**Planning Staff Report to  
Greenville Planning Commission  
March 10, 2022  
for the March 17, 2022 Public Hearing**

**Docket Number:** SD 22-128  
**Applicant:** Whitelane Acquisitions, LLC (Christopher Laney)  
**Property Owner:** Fair Forest of Greenville, LLC  
**Property Location:** 200 Fairforest Way  
**Tax Map Number(s):** M011010100307  
**Acreage:** 8.55 acres  
**Zoning:** S-1, Service District  
**Proposal:** Major subdivision for a 79 lot single-family attached residential development

ALSTON PARK TOWNHOMES

PRELIMINARY  
PLAT - 2

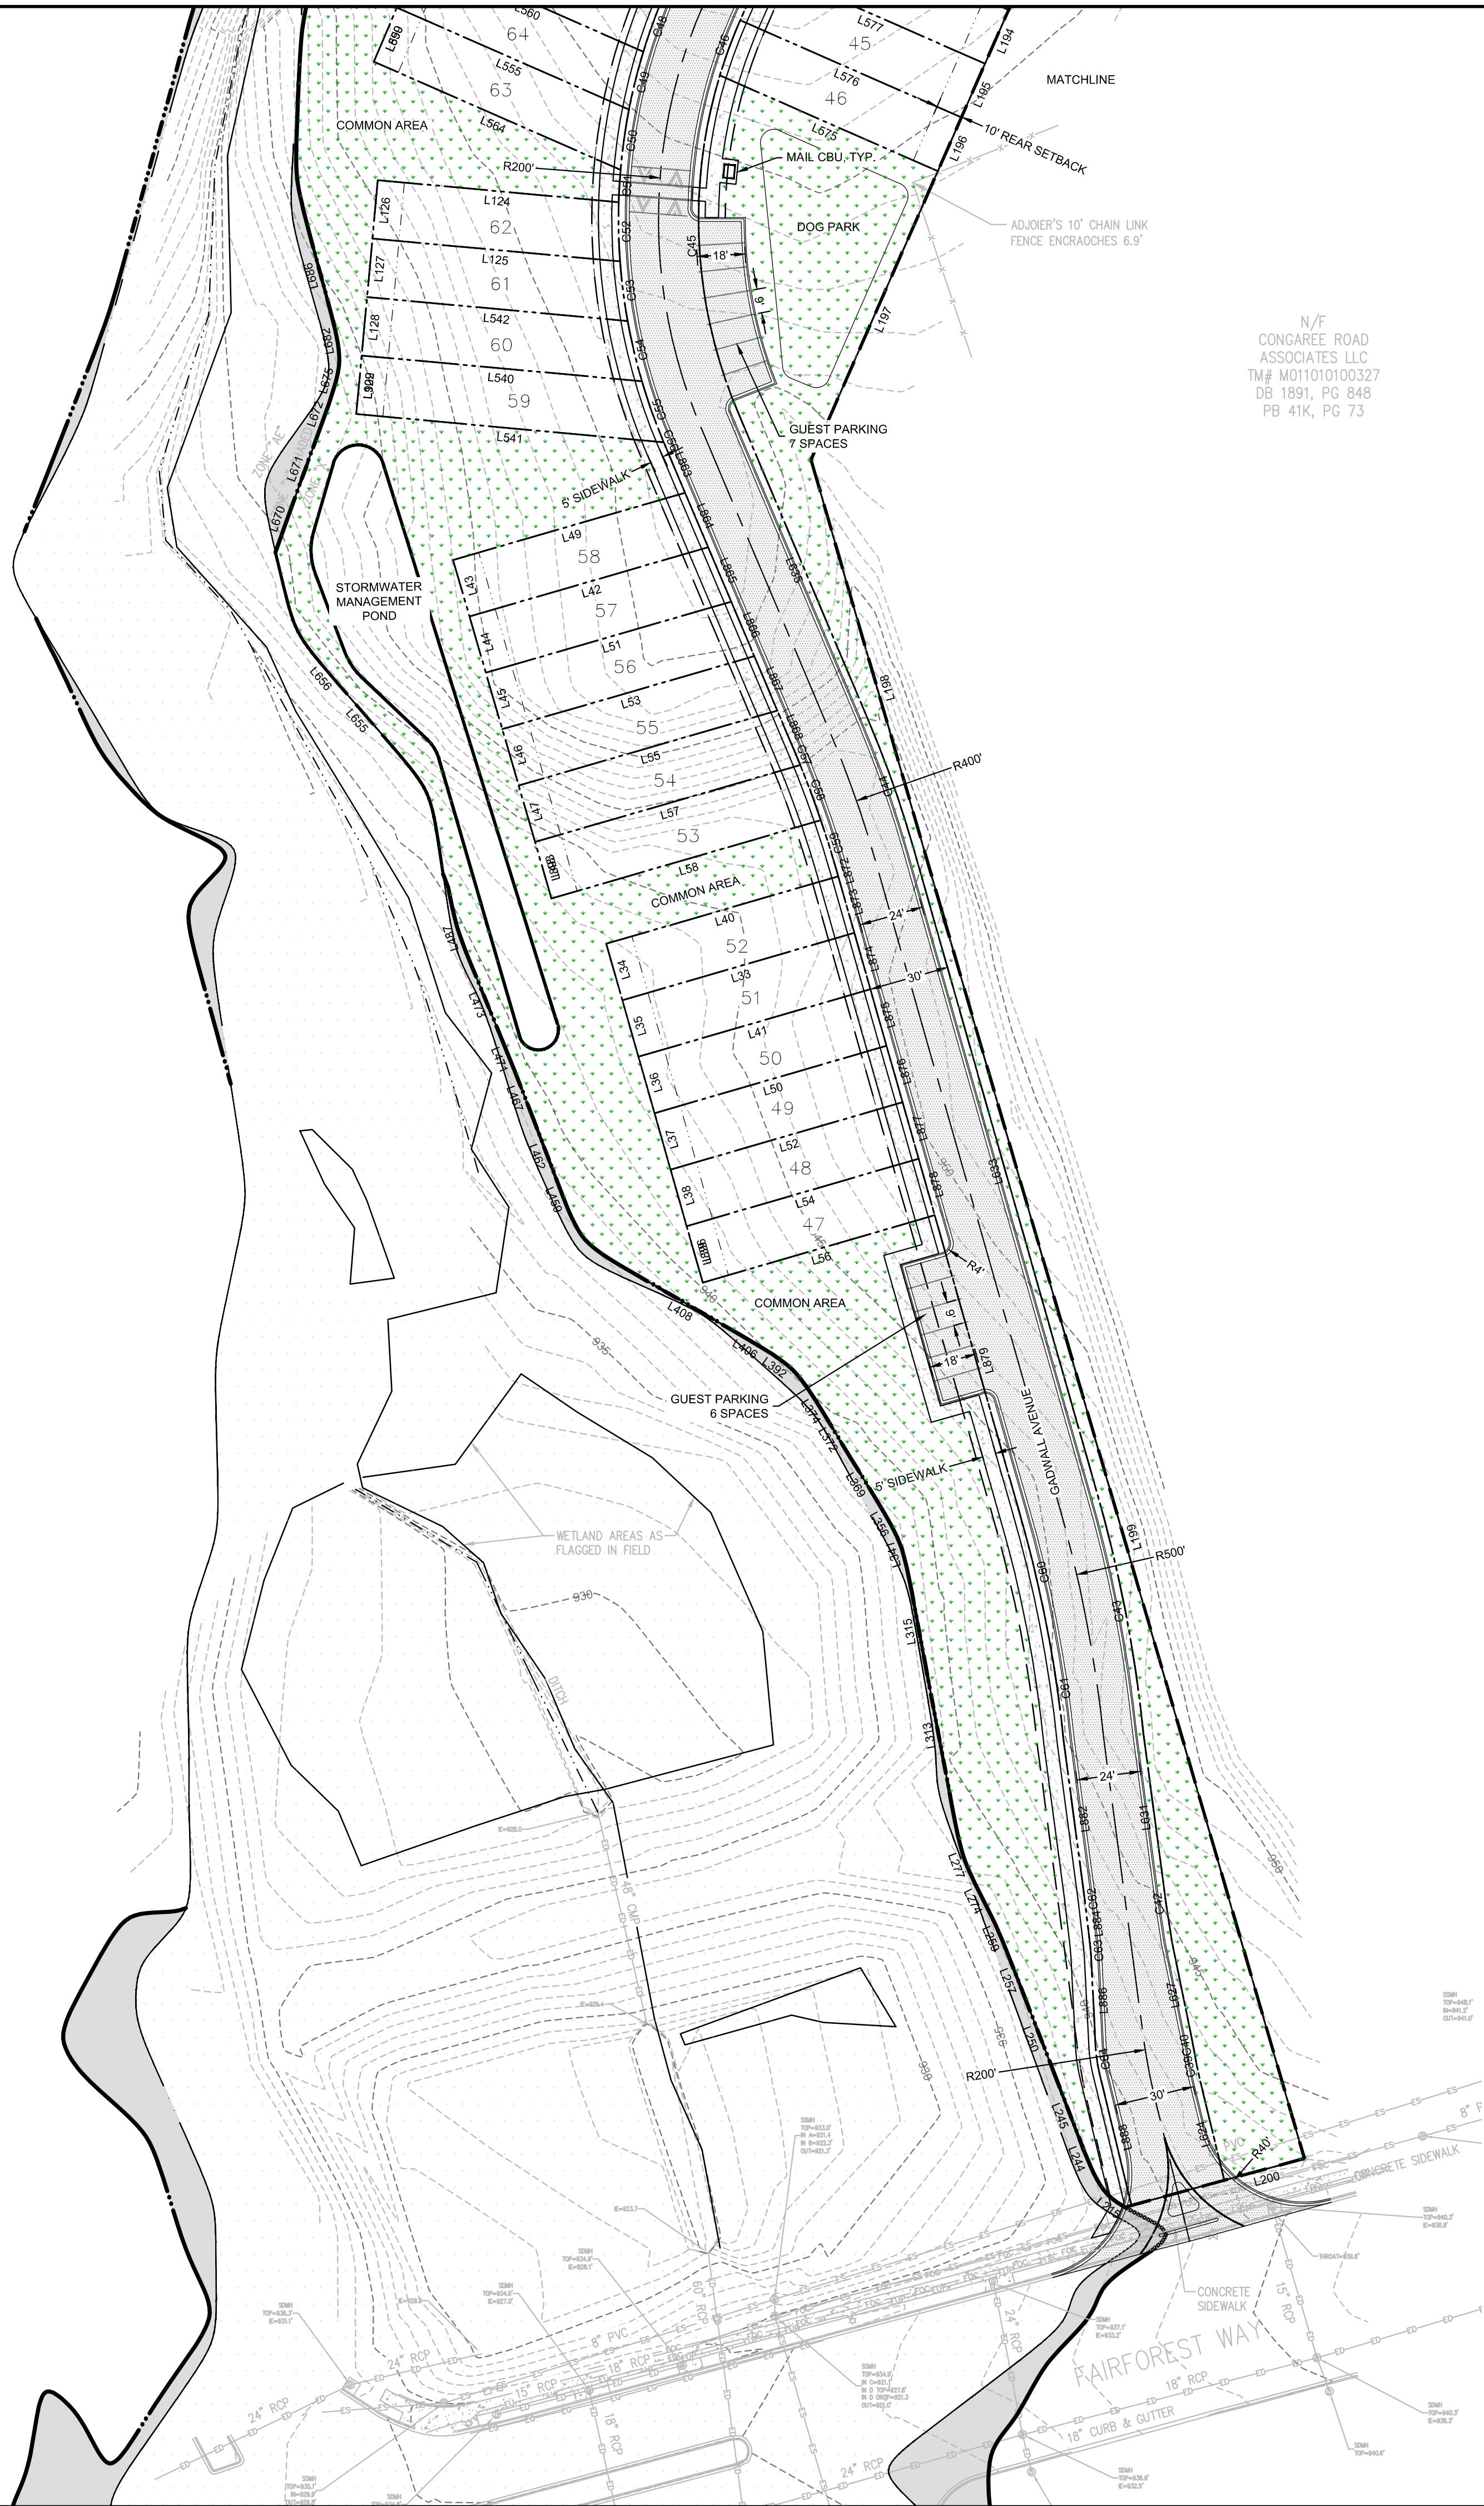
The conceptual location of units on the plan provide evidence that a compliant layout that conforms to applicable dimensional standards, for single-family attached residences, is feasible. Requirements to replace the hammerhead on the south end of Muscovy Trail necessitates a reconfiguration of lots to accommodate a cul-de-sac, and dimensional standards will similarly apply to those lots.

The roadways throughout the development are planned to be private. The roads are proposed at a width of 24 feet from face-of-curb to face-of-curb, but through Civil Engineering Department conditions are required to be 28 feet in width. Pavement widths will need to be adjusted accordingly. The hammerhead turnaround at the south end of Muscovy Trail does not comply with the City's Design and Specification Manual, and will need to be replaced with a cul-de-sac. Civil Engineering Staff is confident this can be handled during the site plan permit review process. To maintain activation of Ridge Road, installation of an offset cul-de-sac should be offset towards the interior of the property.

- 1) Per Land Management Ordinance 19-4.3.1(3), "Single-family attached dwellings shall comply, as applicable, with the standards in subsection 19-6.8."
- 2) Direct vehicular access to parking for individual units shall not be provided off existing streets (Ridge Road or Fairforest Way. Garages for units 1 through 31 shall face away from Ridge Road.
- 3) Parking for units shall not obstruct sidewalks proposed for the development.
- 4) To maintain activation of Ridge Road, installation of an offset cul-de-sac should be offset towards the interior of the property.

- 8) On the southeast side of Muscovy Trail, the two hammerhead road configurations will not be allowed. A cul-de-sac will be required to be built; therefore, the townhome layout in this area will need to be modified.
- 9) The typical section provided does not meet the City's standard. The road will need to be a minimum of 28 feet in width (face of curb to face of curb).
